SEXTON CONSULTING

ADDITIONAL INFORMATION

REGISTER REF.: **SD22A/0081**

LOCATION: Kingswood Farm, Moneenalion Common Lower, Kingswood, Dublin 22

Fig.5: New Holland T8 Tractor Geometry Specifications (Farm Machine of the Year 2014)

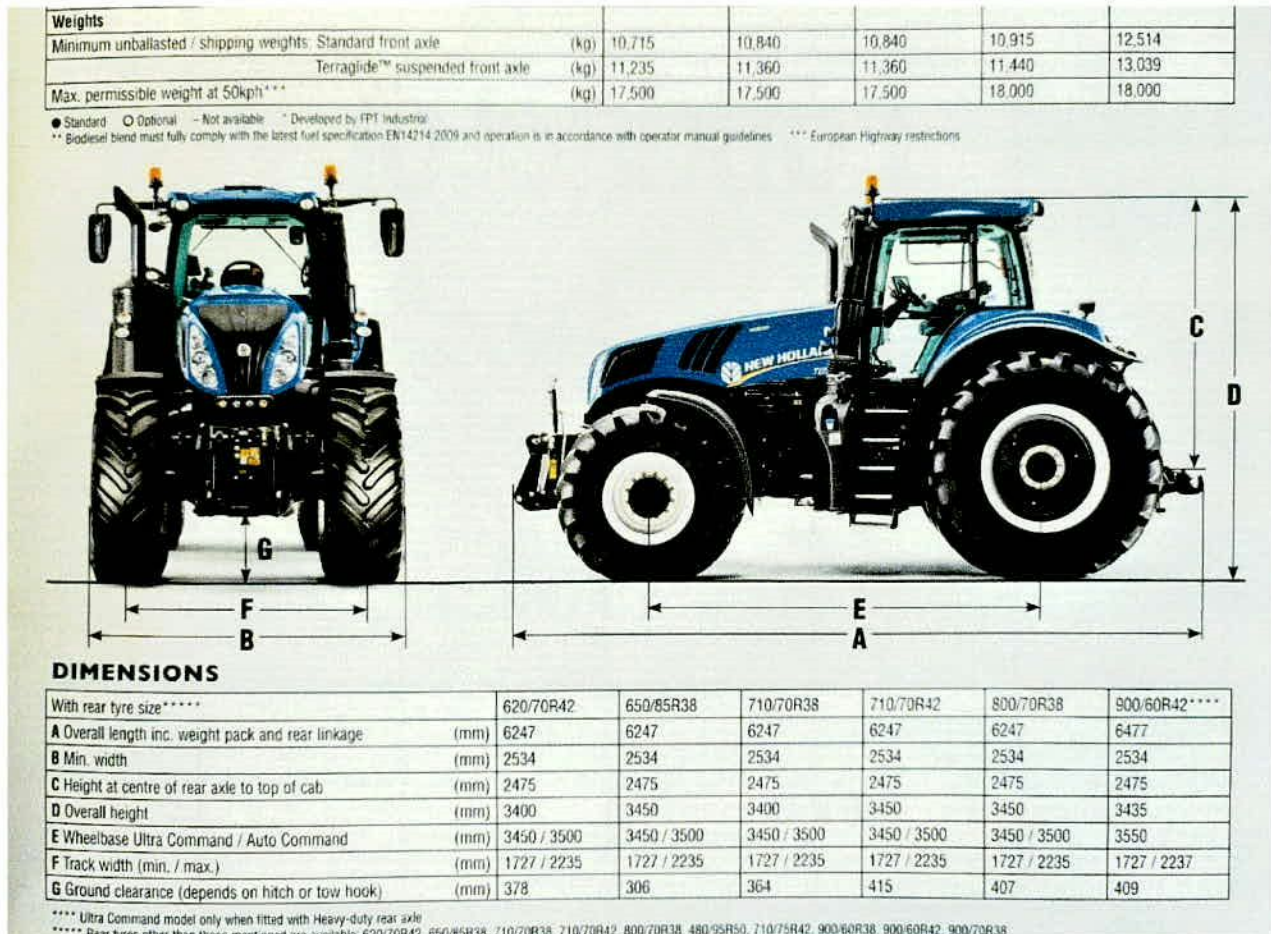
(3) Further detail regarding the main entrance road (Country Lane's Road Traffic & Road Geometry) to include a text rationale explaining the traffic movements where the narrow lane widths (4.5m in places) occur.

To give a more tangible example of the type of farm vehicle, in this case a tractor unit, that may be encountered on any Rural Road in Ireland, at any time, we enclose in Fig 5 below an extract from a popular farm tractor sales brochure, namely the New Holland T8 Tractor Unit, which shows dimensions and scale for this machine.

While we understand that the T8 Tractor Unit is one of the biggest farm tractor units currently available in Ireland, according to a New Holland Sales Agent we spoke with, the slightly smaller but wider New Holland T7 Series machine, at 2.75m wide, is in fact a much more common and popular machine among farmers across the Irish countryside.

Fig.A1: PROPOSED PEDESTRAIN STAIRS ACCESS OFF R136:

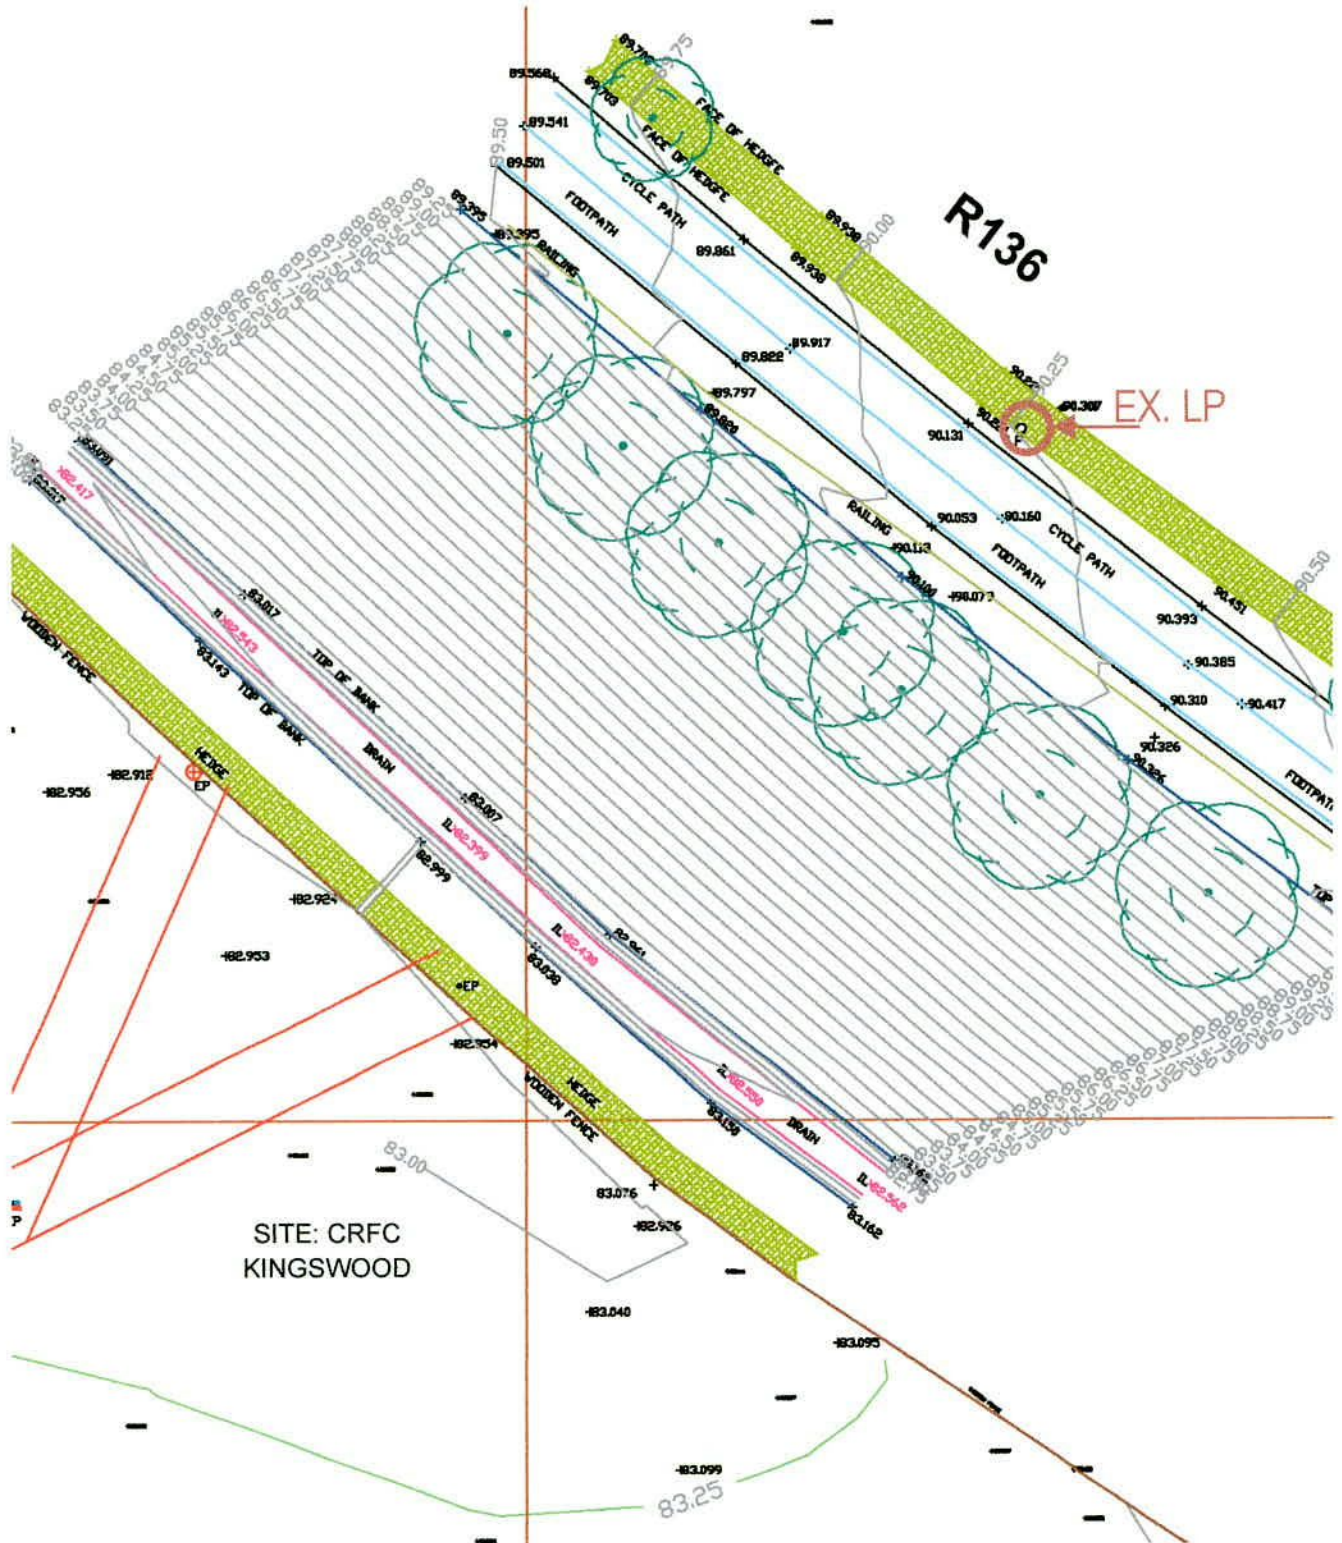
(1) *details/drawing of proposed stairs specification (materials, finishes, hand railings, lighting, gate, gradients, etc).*

(a) *Plan drawing, section drawing and structural drawings (including rebar schedules where applicable).*

(b) *Preventive railing at top of stairs (Noting the 7m level difference between top and bottom).*

The Pedestrian Access Stairs, on the other hand, must overcome a more significant level difference which is indeed just over 7m vertically. The stairs are also detailed in the bound A3 design set, specifically on Drawing Nos. A.03.05.1.3 and A.03.05.1.4 where it is shown in Plan, Sections and Perspective Views. Details of finishes, hand railings, landings, areas of tactile pavement etc are included.

To achieve a safe pitch for the Pedestrian Access Stairs, the R136 embankment earthworks will need to be extended out slightly, and locally, in order to provide proper direct support on new compacted fill material for the proposed new reinforced concrete stair. This embankment extension will be done using stepped benches in strict accordance with Transport Infrastructure Ireland's (TII) Standard Construction Details ref. CC-SCD-00608 and a copy of this drawing is included in Appendix B for ease of reference. There will be a number of level landings between flights, including top and mid-level rest area landings. The stair flight structure will include a formed RC key at the base of each RC flight, to effectively fix them in place.

At ground level on the CRFC site side there is an unlined drainage ditch feature at the toe of the embankment just outside the site boundary fence. With the local outward extension of the embankment this drainage feature will also need to be piped for the width of the extended embankment as shown on Drawing Nos. A.03.05.1.3 and A.03.05.1.4.

The Stairs and its landings will be fitted with stainless-steel guardrails and its handrail will include discrete integrated lights along its path. The Cycle Track access will have a timber handrail and standard bollard lighting at discrete positions along its entire Cycle Track route. Refer to the overall site Layout Drawing No. A.03.05.1.1 as well as Wink Lighting Report and associated Drawing No. A.03.05.1.4.

Fig.A2: PROPOSED CYCLE TRACK STAIRS ACCESS OFF R136:

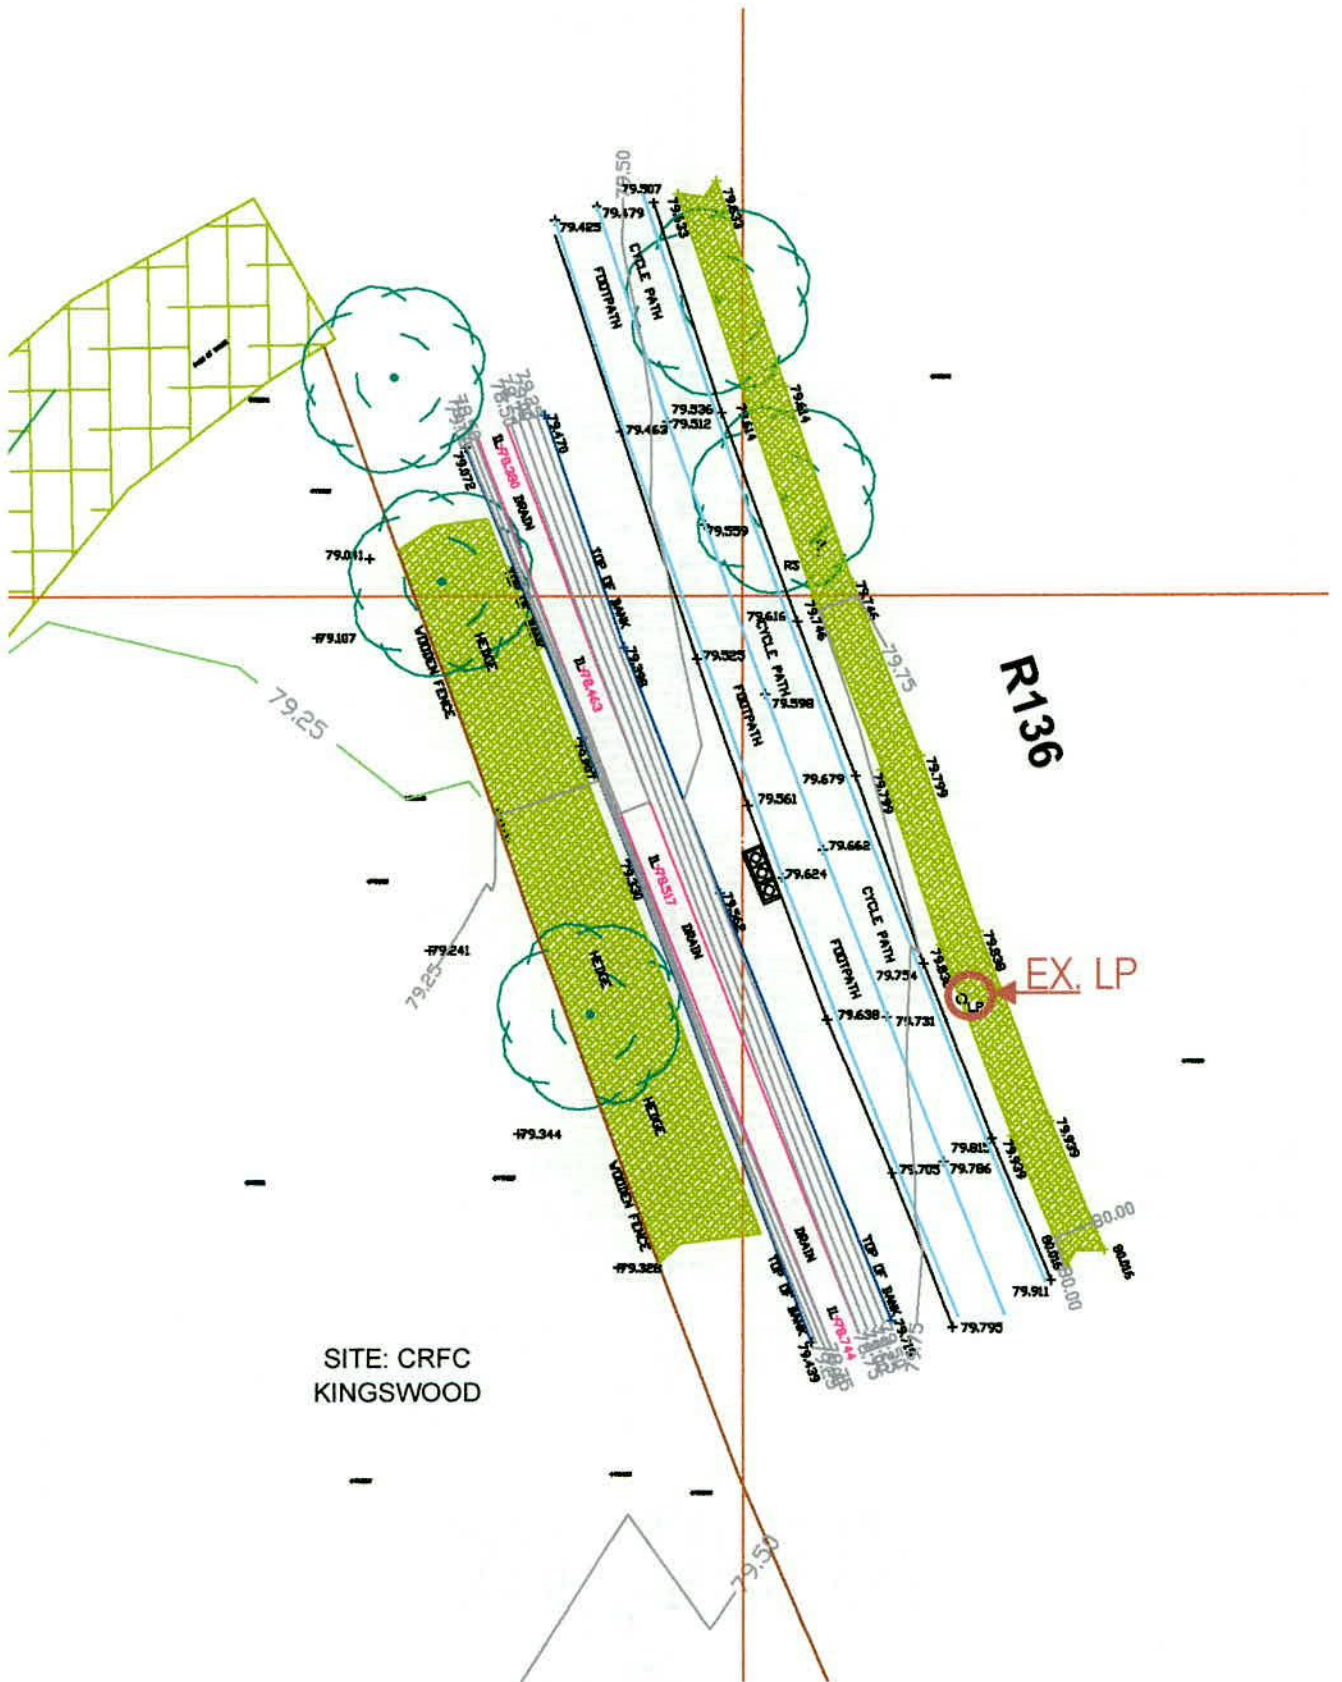
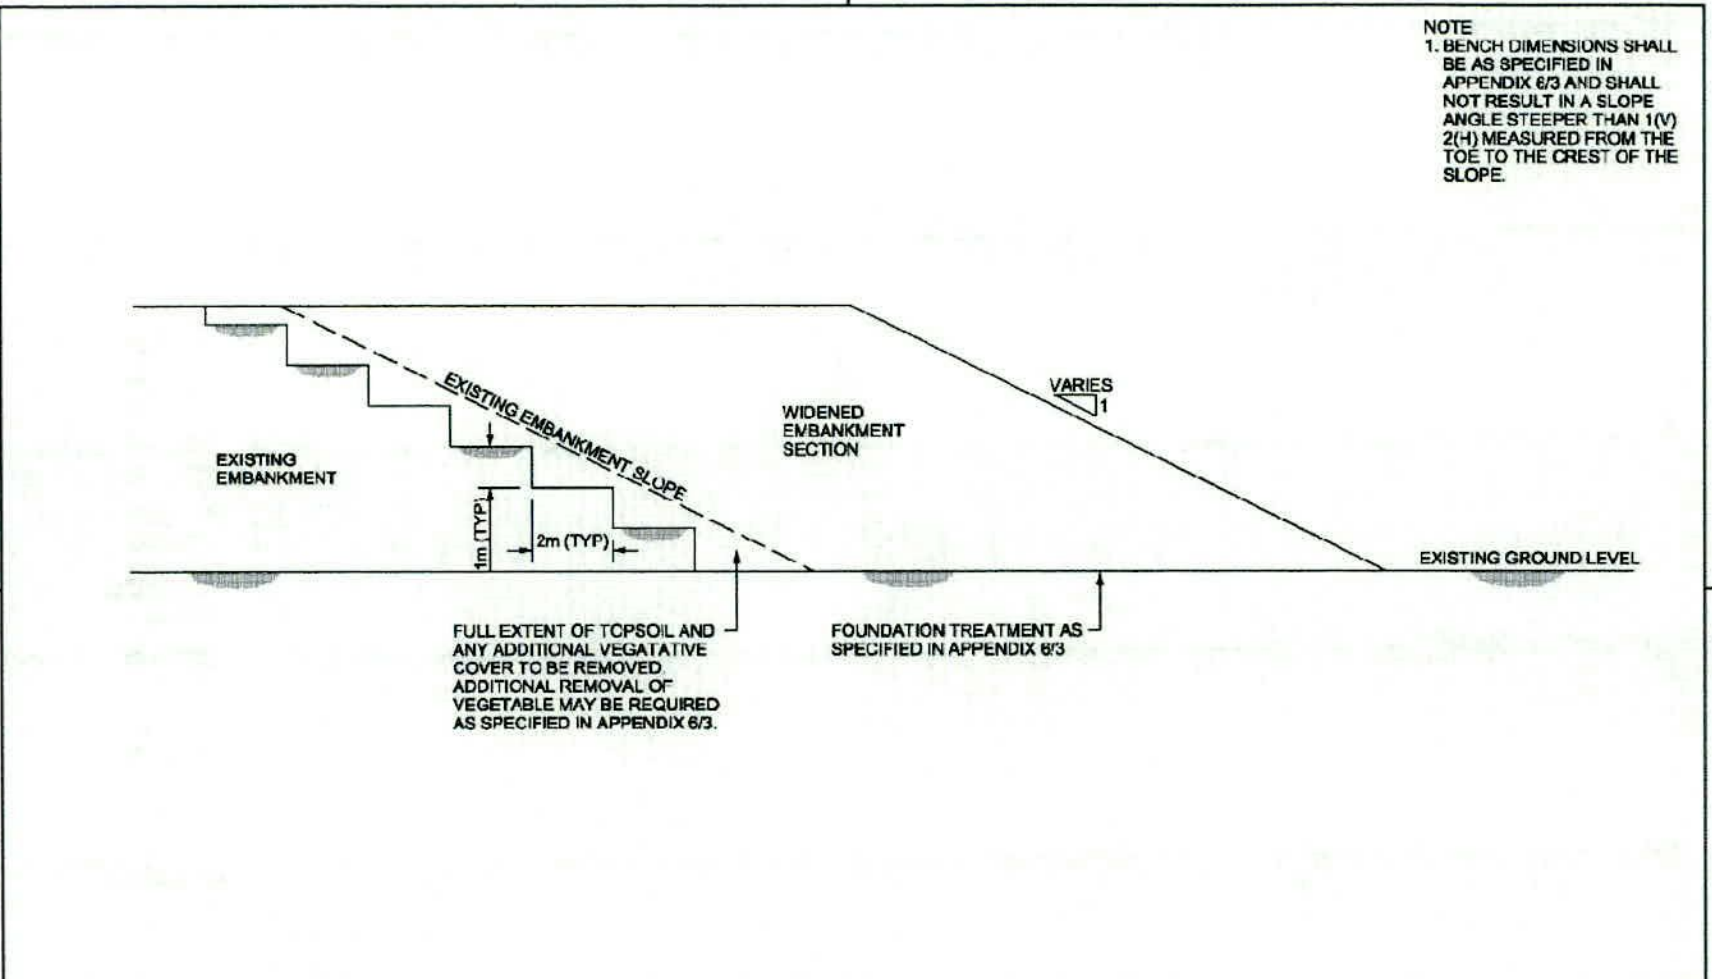
(2) *Further detail regarding proposed cycle track/entrance:*

(a) *Public lighting to be provided along any darkened sections of path, subject to consideration of ecological impacts.*

The proposed Cycle Access Entrance is detailed in the A3 bound design set of drawings on Drawing No. A.03.05.1.2 where it is shown in Plan, Elevation, Section and Perspective View. This access is near level with the adjacent R136 Cycle Track and Footpath with a nice gentle fall into the site of approximately 1/30 or 3.3%. There is a small, grassed drainage ditch present between the edge of the R136 Footpath and the existing fence boundary at the top of the distributor road embankment. This ditch will need to be traversed here and so we proposed that it is piped locally and in accordance with current drainage design and detailing standards and Civil Engineering good practice. The handrail to the crossing is envisaged as a simple but robust timber railing to guard against the slight resulting change in level.
